EQUIPMENT/FURNISHINGS - RH REFRESHMENT CENTER AND LH FORWARD CABINET REINFORCEMENTS INSTALLATION

Structural analysis with RH Refreshment center and LH forward cabinet indicates the need for new reinforcements installation.

To install reinforcements on the RH refreshment center and LH forward cabinet, and to replace rivets of the floor support of the RH Refreshment Center.

FIGURE 7 - LH FORWARD CABINET - REWORK - GROUPS 8 AND 9
(Sheet 1 of 4)

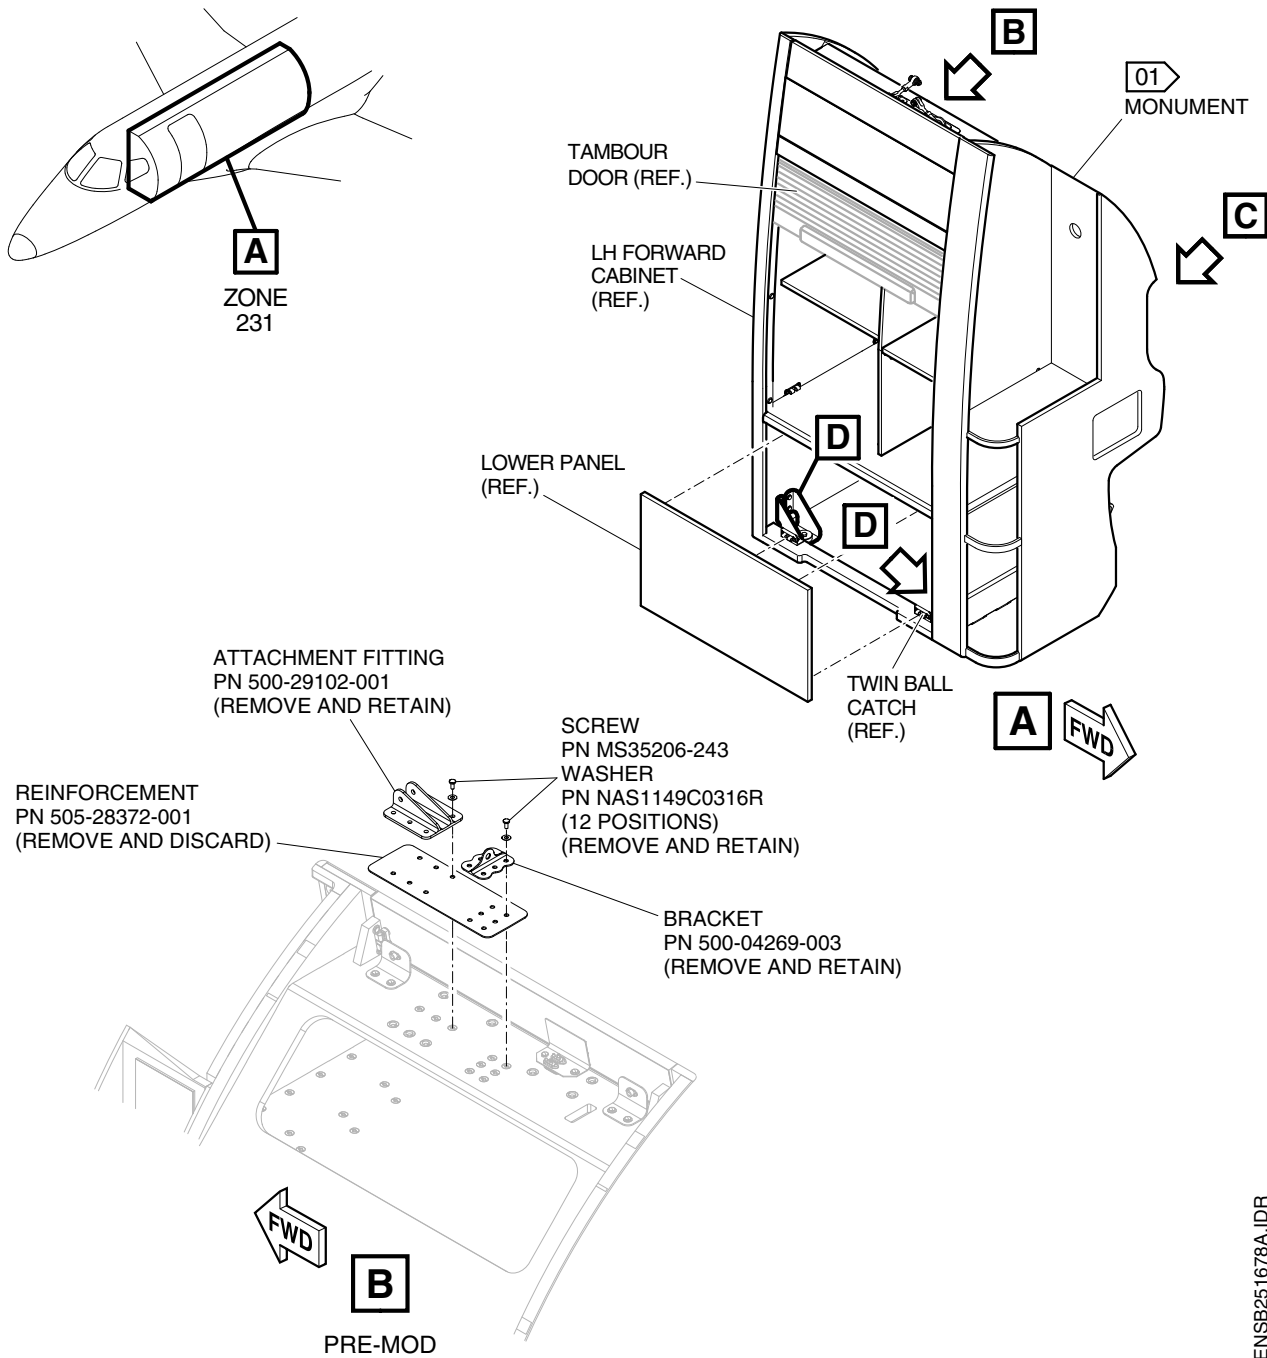
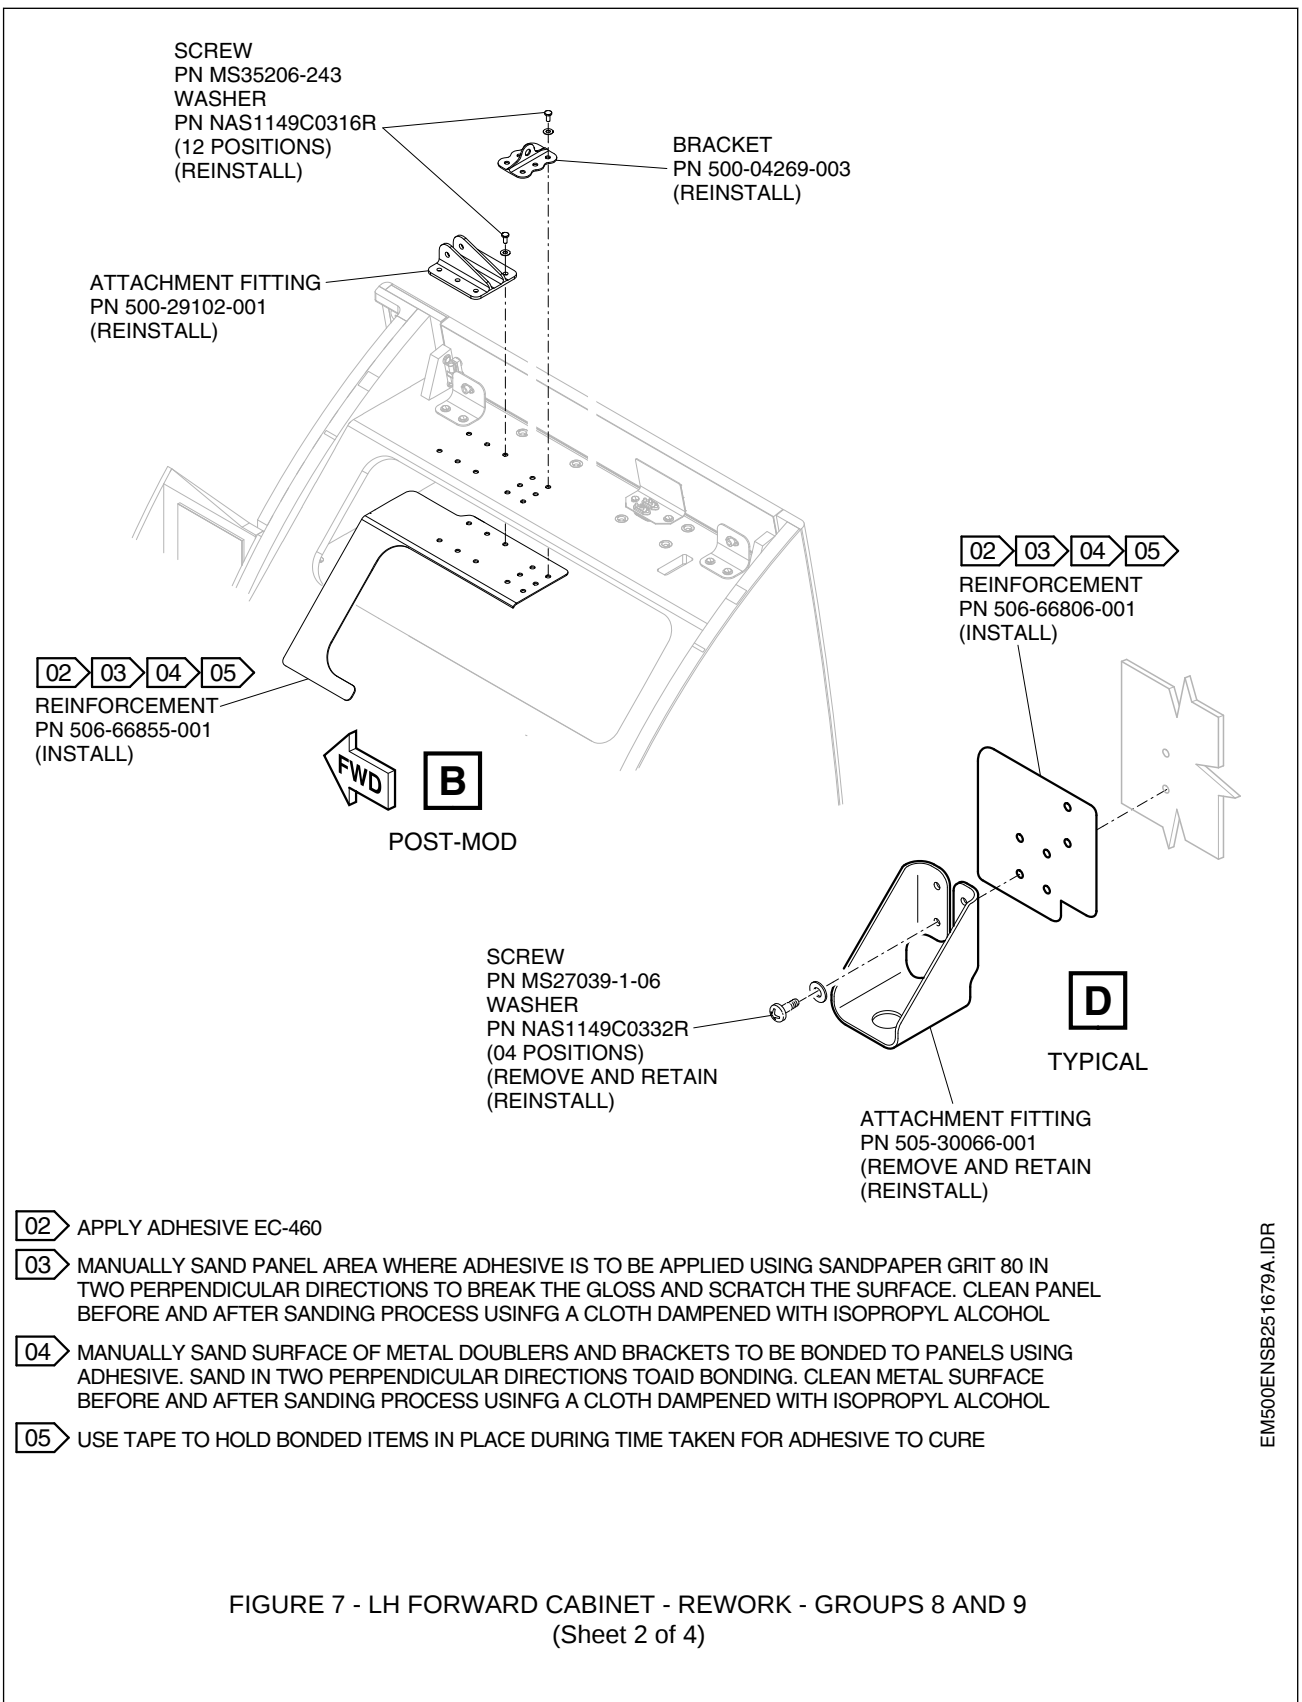
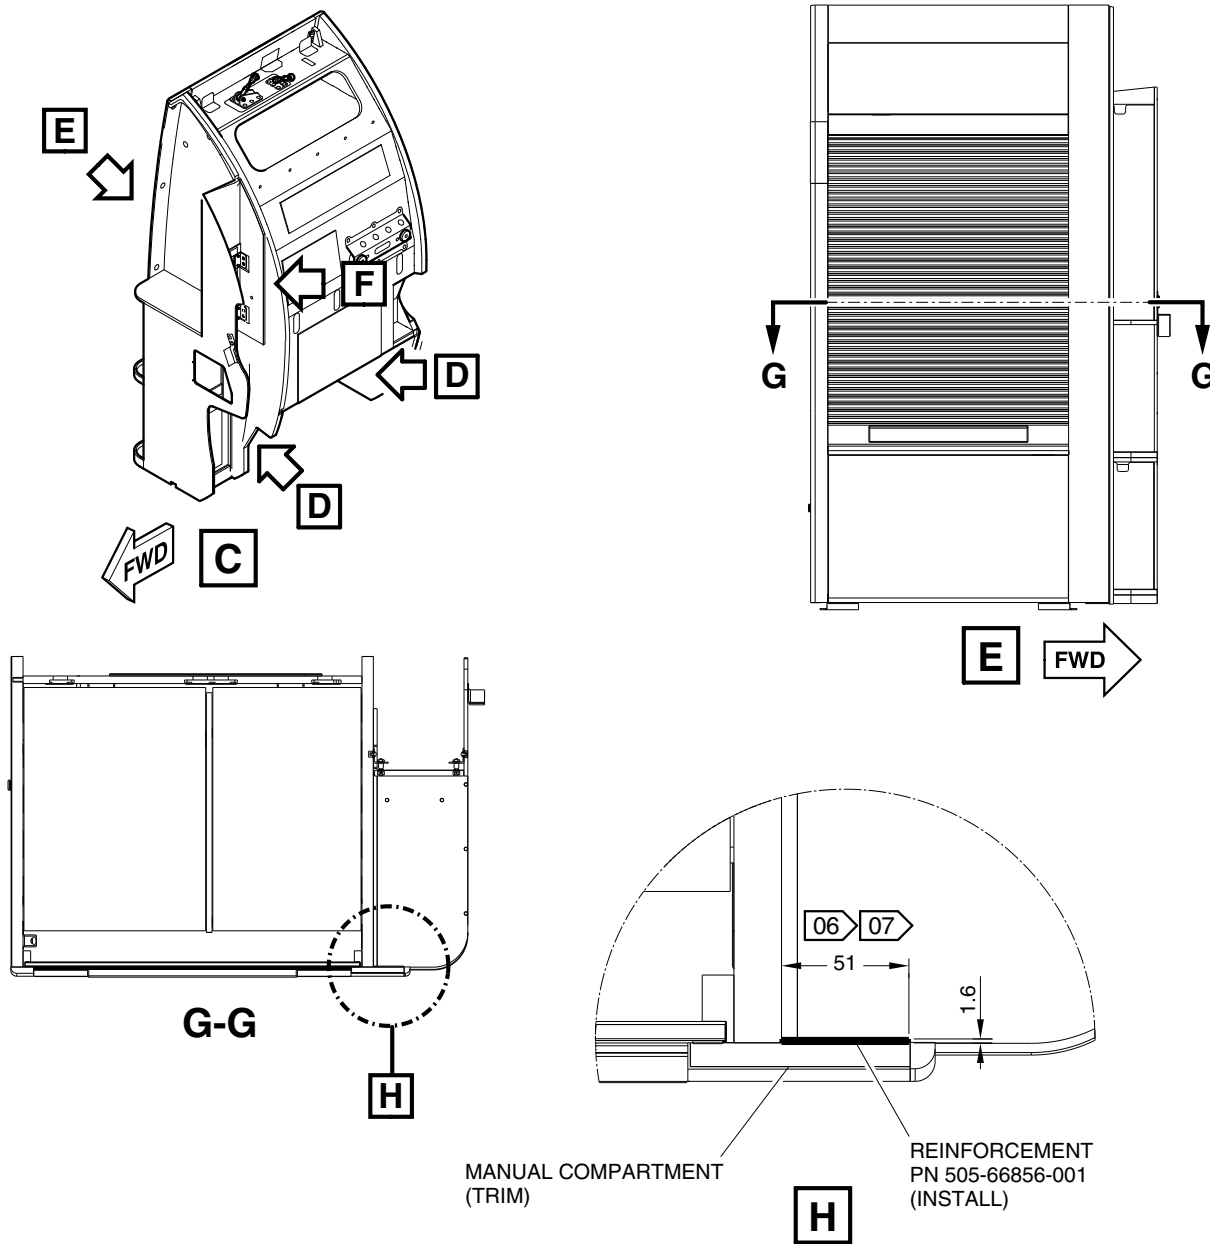
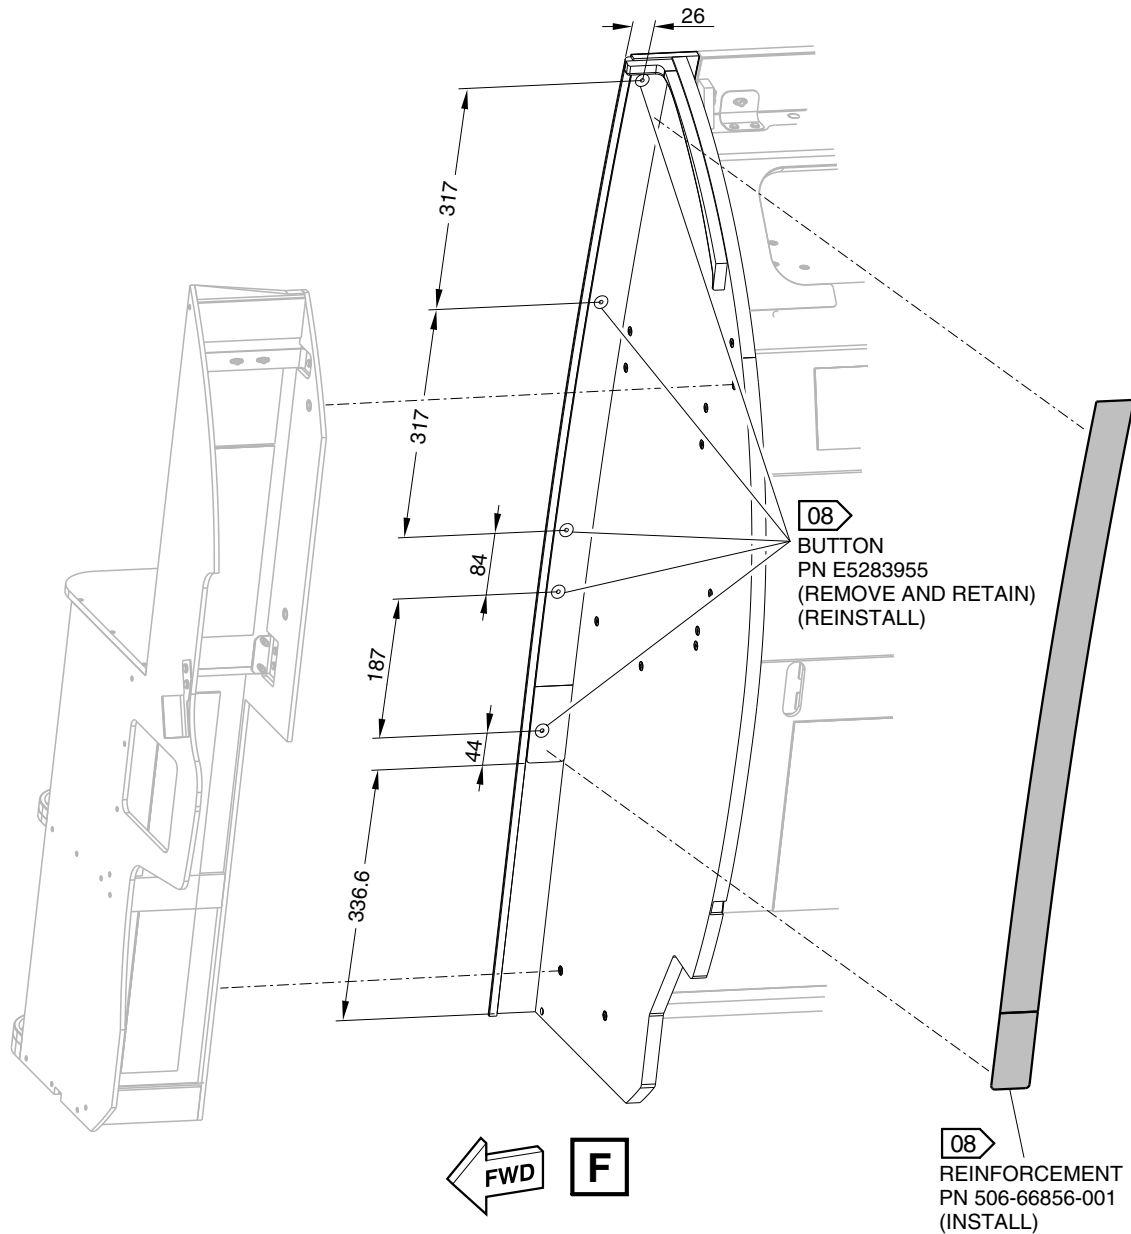
- (10) Remove the LH forward cabinet. Refer to [AMM TASK 25-26-01-000-801-A/400](#) - LH Forward Cabinet - Removal.
- (11) Rework the LH forward cabinet according to instructions given in [Figure 7](#).

01 USE PERMANENT INK MARKER TO REIDENTIFY MONUMENT

06 TRIM MANUAL COMPARTMENT

07 APPLY PAINT IP1083-740 WITH PRIMER 20P20-3/K1G

02 APPLY ADHESIVE EC-460

08 POSITION, TRANSFER AND DRILL THE HOLES AS DIMENSION INDICATED
